# FINAL REPORT – PHASE II

Measurement and Modeling of Ecosystem Risk  
and Recovery for In Situ Treatment of Contaminated Sediments

SERDP Project ER-1552

August 2013

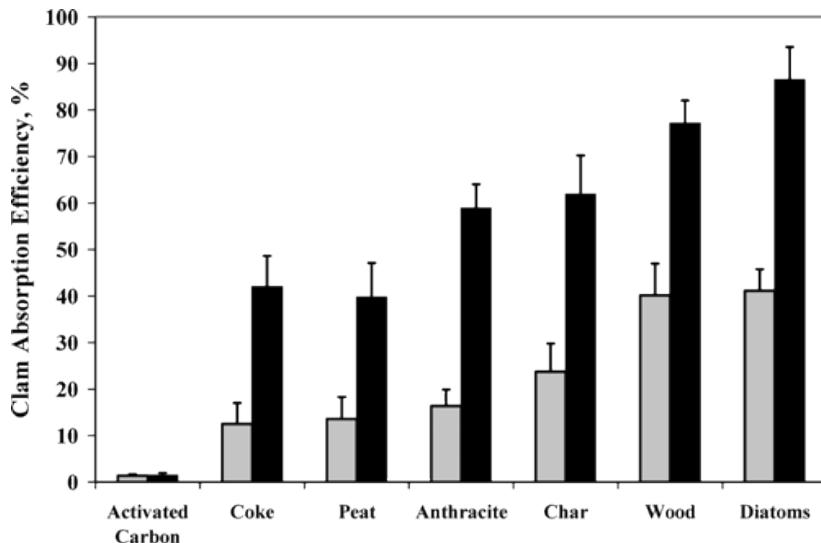
**2. List of Tables and List of Figures.** Please change the List of Tables and List of Figures so that only the pertinent, short sentence is reflected in the list. For example, Figure 1 should read only “Absorption efficiency results for various particle types for the marine clam *Macoma balthica*” in the List of Figures.

Figure 17. Measured (solid symbols) and modeled (outlined symbols) data for 28-day PE uptakes five years after AC-amendment (single data point) of (A) PCB 101, (B) PCB 153, and (C) PCB 180.

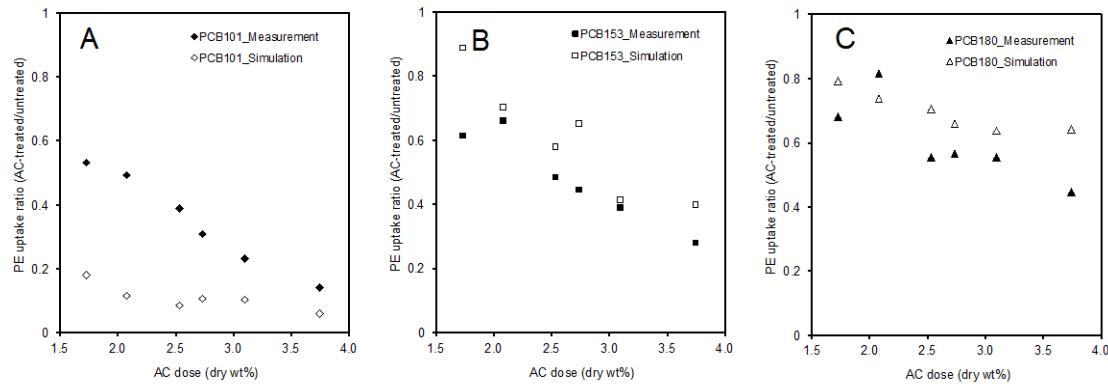
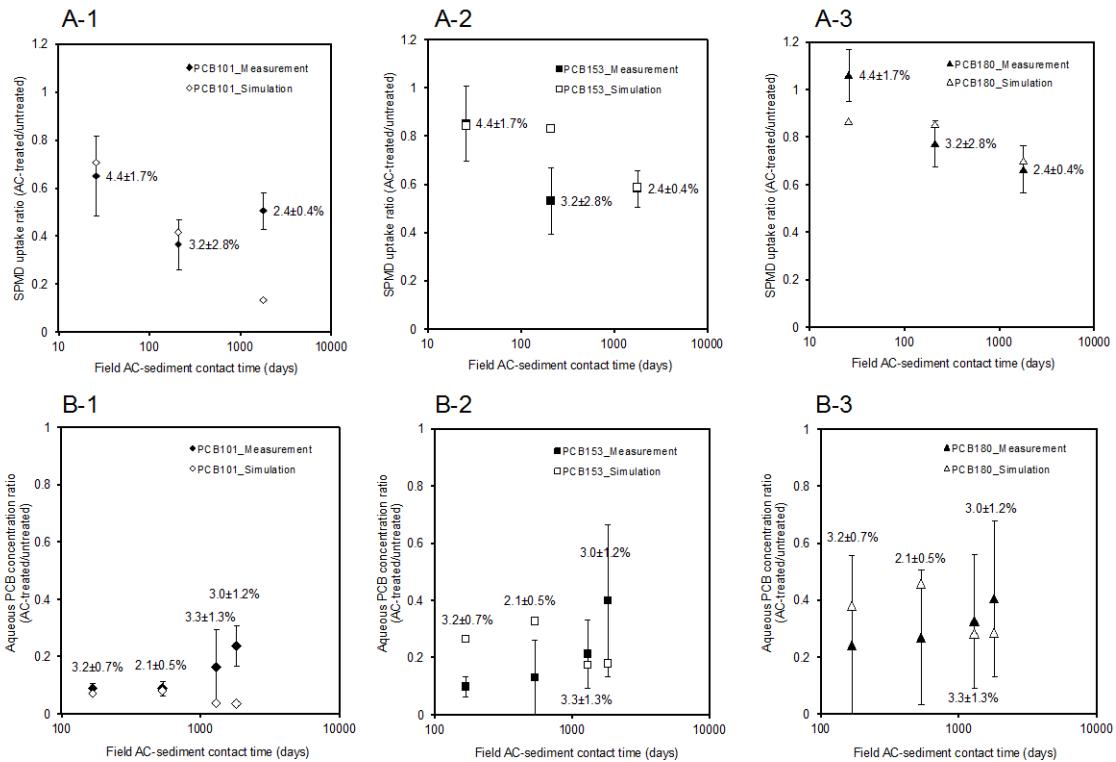
Please provide tables showing the actual measurements/data used to construct Figures 17 and 18. To be clear, this should be the actual measures of PCBs (not percent reduction) for all replicates, as well as the mean/average calculated and standard deviation as expressed in the figures. It would also be helpful to include the corresponding model prediction(s) (as expressed in Figure 18A, for example).

**Response:** Data and simulation results for Figures 17 and 18 are provided in Tables C1 and C2 in Appendix C.

**11. Section V: Results and Discussion (Figure 18).** Additional clarification is needed to help understand these figures. For example, are the values expressed on the plots (e.g., 4.4, 3.2, 2.4) OC measurements? Evaluation of the figures is complicated by the x(presumed) AC measures, from 2.1 to 4.4, and the wide standard deviation bars in B-2 and B-3. Is there a way to normalize the data, for example, based on measured OC (divide the PCBs by the % OC)?

**Response:** The values in the plots are AC dose (the figure caption was revised for clarity). Although the dose normalization will certainly make the figures look better, normalizing the data by AC dose may be inappropriate for the two reasons. First, the TOC measurements and SPMD uptake sampling were not taken at the exact same locations, which may hamper a direct correlation between samplers and AC dose. To overcome this issue, for the 5-year data shown in Figure 17, sediment cores were collected right next to the passive samplers. Secondly, although a good relationship between AC benefit and AC dose were observed in our study, quantitative relationship or linearity has not been validated with varying contact times. Therefore, we believe the current figures deliver our data more objectively.

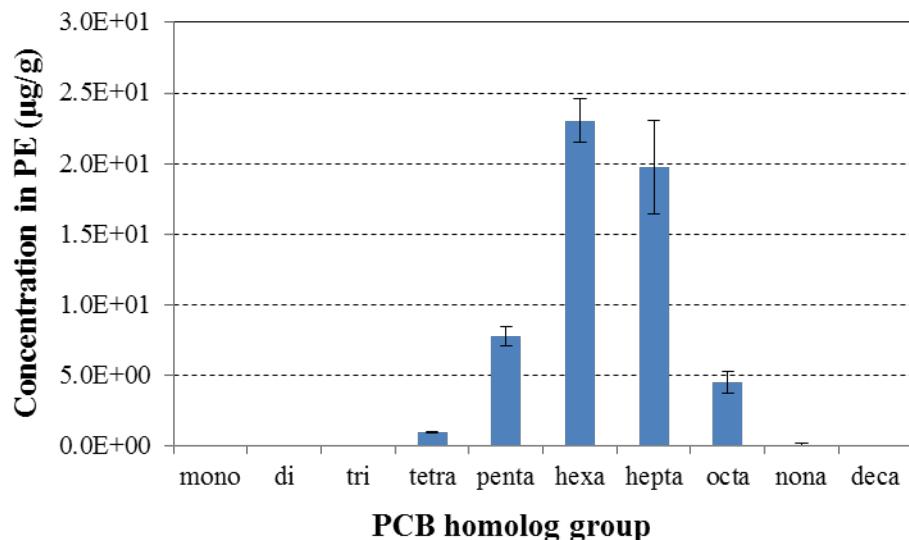
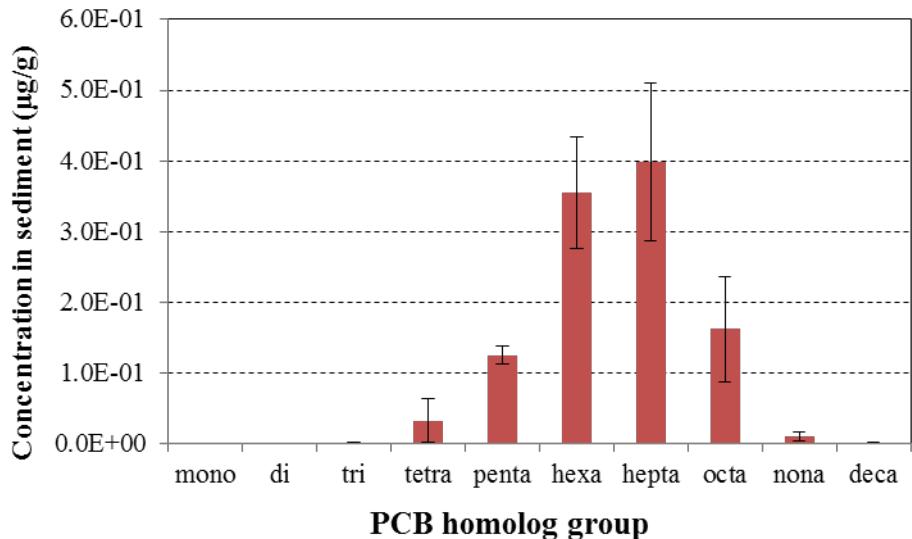
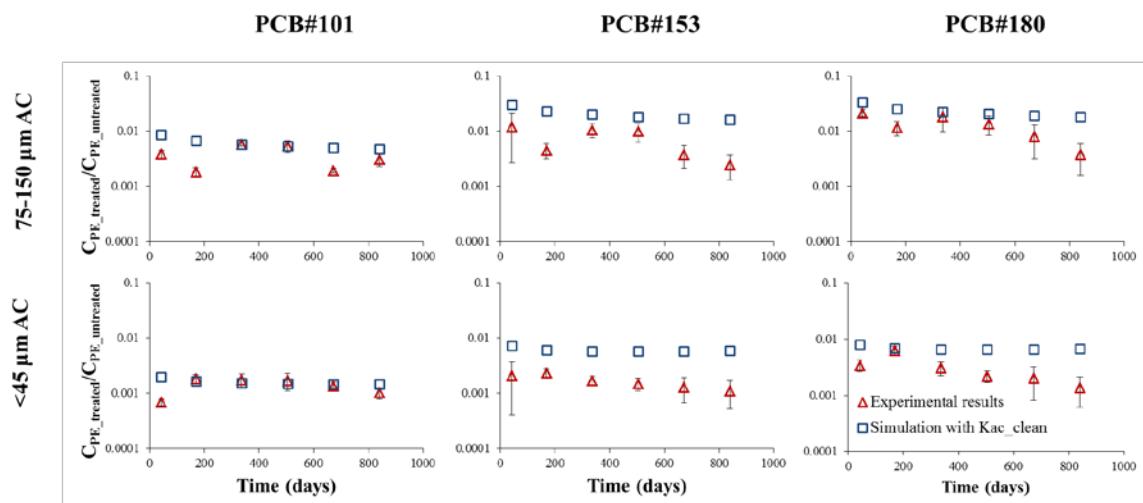
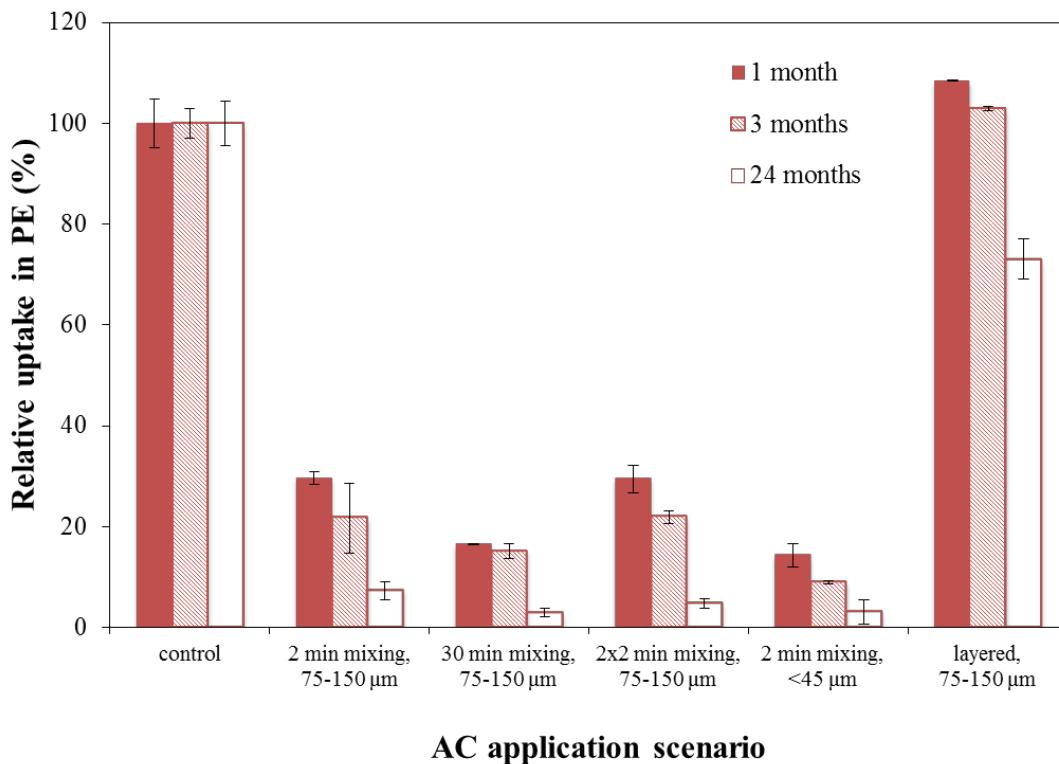
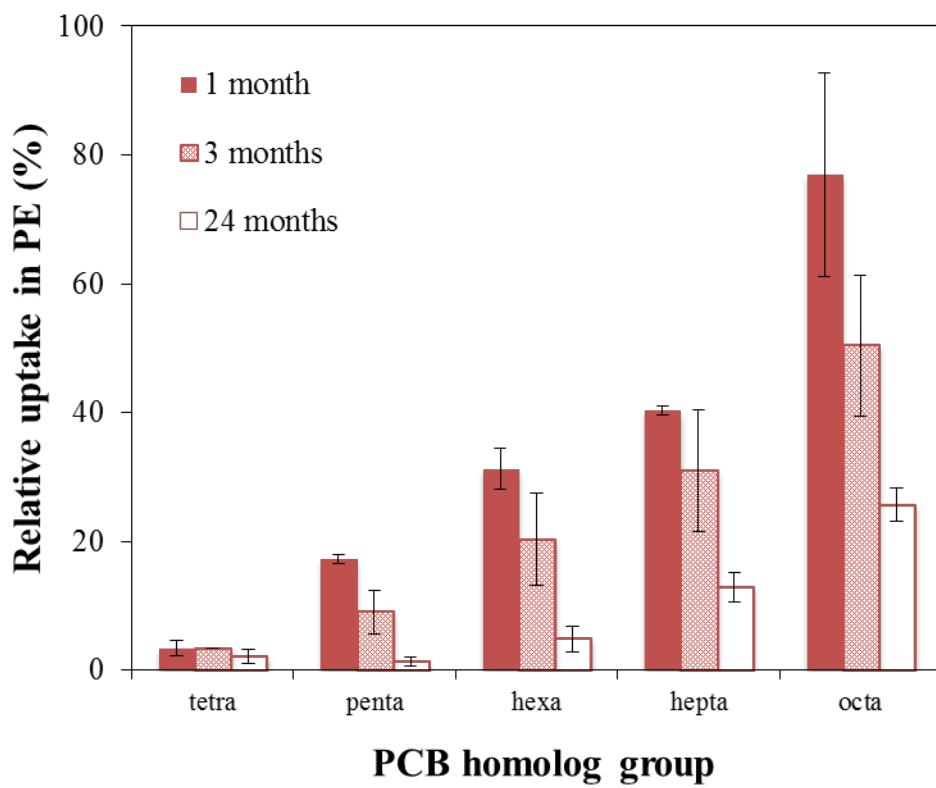
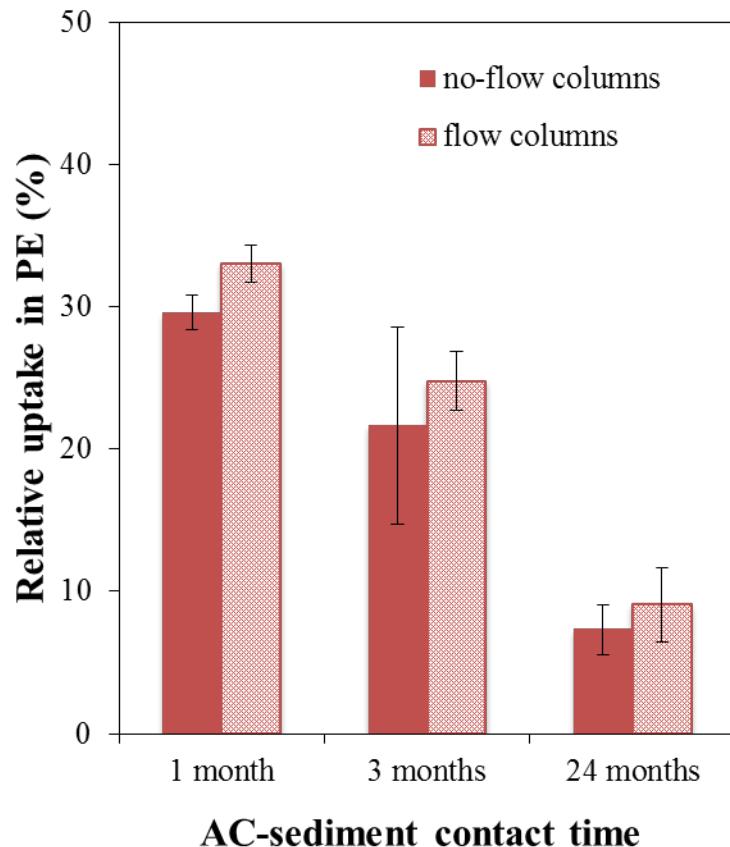
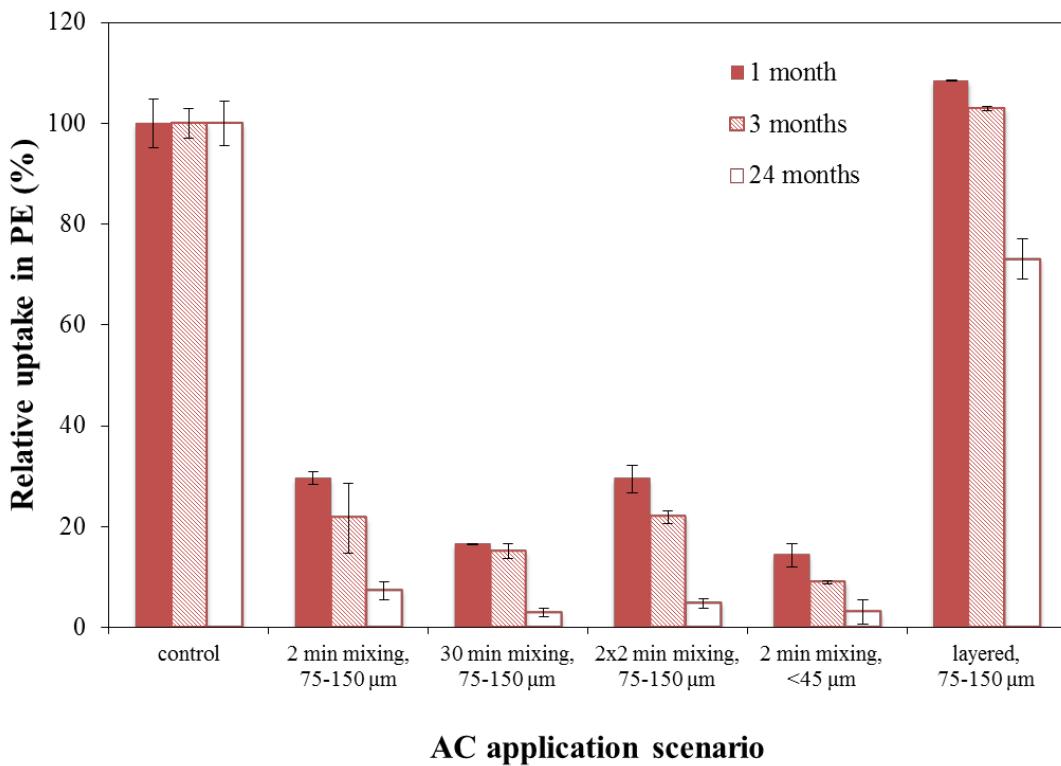
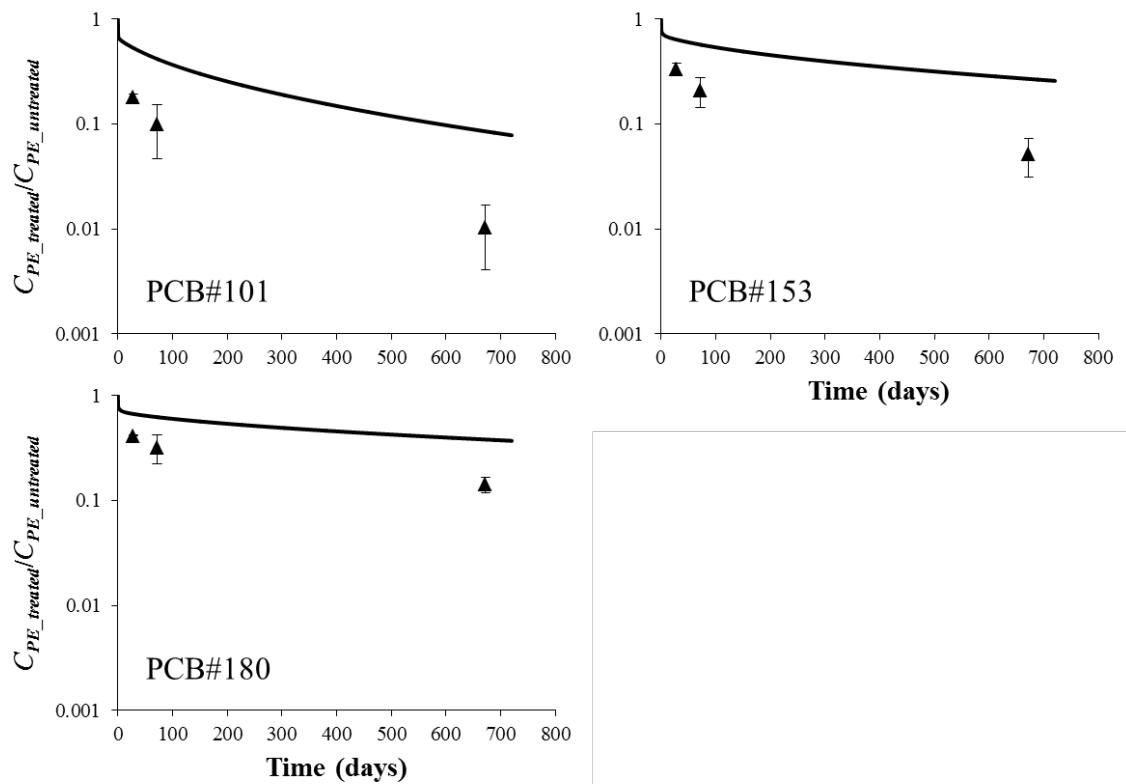
**12. Section V: Results and Discussion (Figures 24-30).** Please provide the data in an appendix in tabular format that supports each of these figures. This should be the actual measures of PCB congeners used to construct the ratios and reported percentages in these figures.

**Response:** Data for Figures 24-30 are provided in Tables C3-C9 in Appendix C. Both actual measurements and the reported ratios/percentages are shown in the tables.

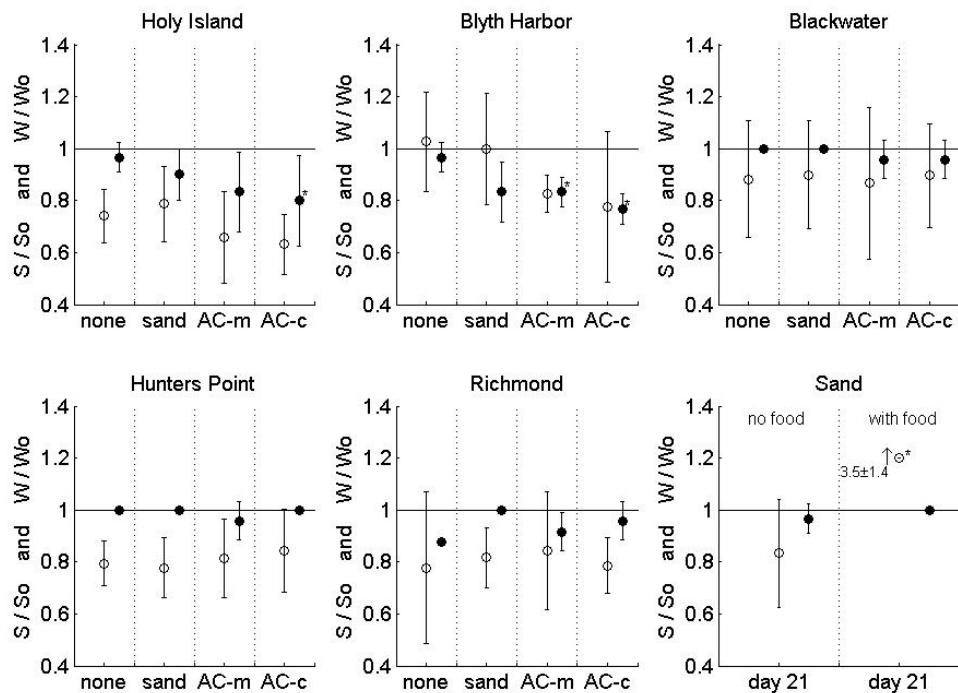
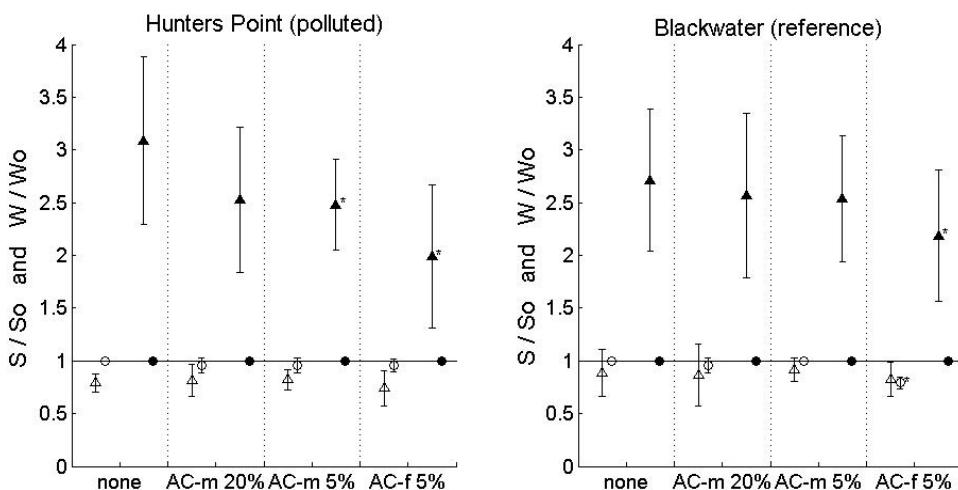
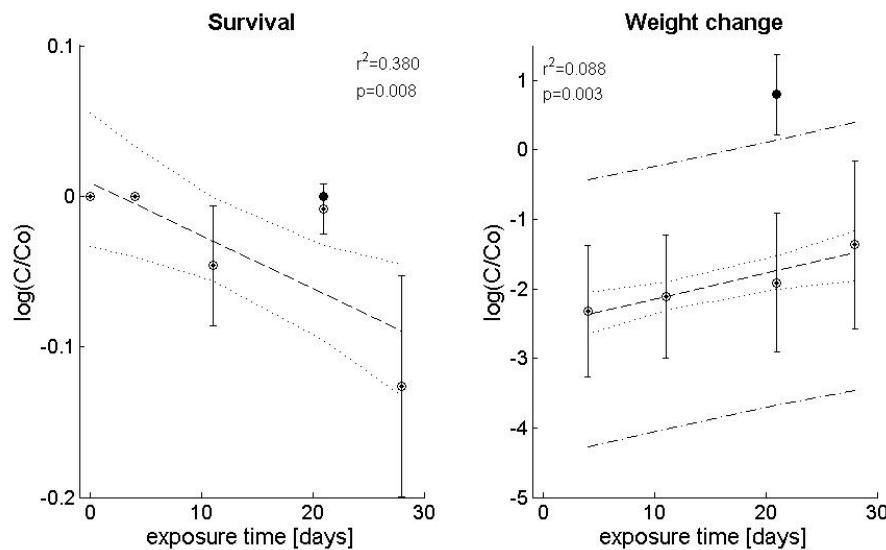
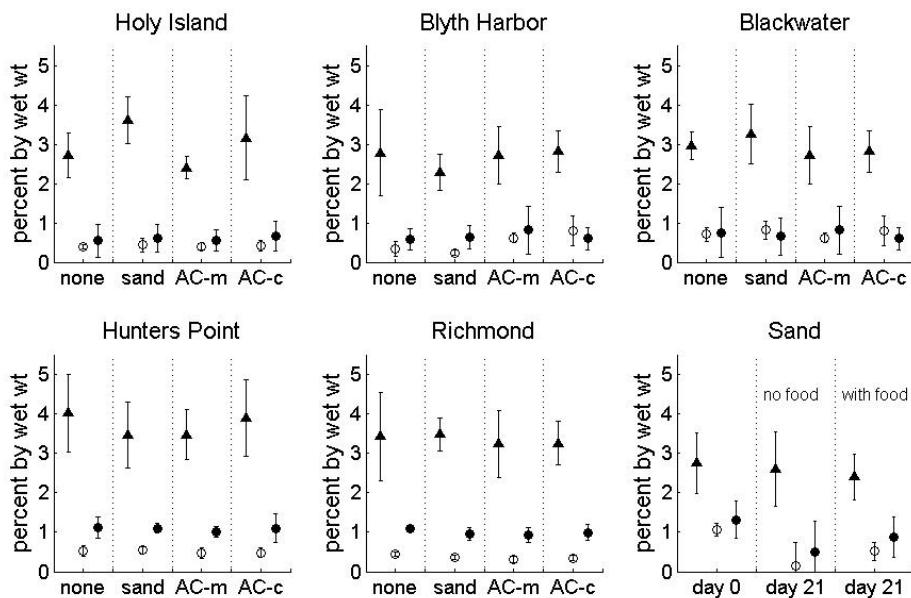
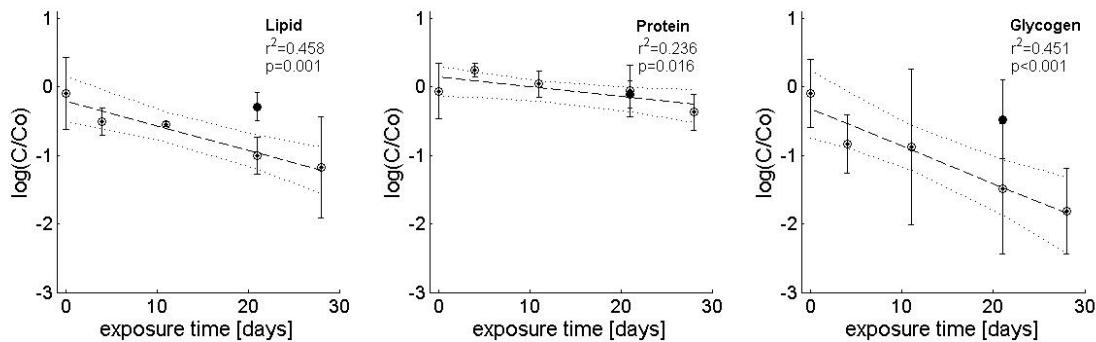
**14. Section V: Results and Discussion (Figures 33-37).** Please provide the data in an appendix in tabular format that supports each of the figures in this section. These data should include the site name, the treatment, the number of worms input to the beakers and the number of worms recovered, the initial worm weight/individual, the final worm weight per individual, and any mean and/or standard deviation that may have been calculated. The need for data also pertains to the individual measures of N, protein, lipid, and glycogen.

**Response:** Data for Figures 33-37 are provided in Tables C10-C13 in Appendix C. The tables include all data listed in the comment.
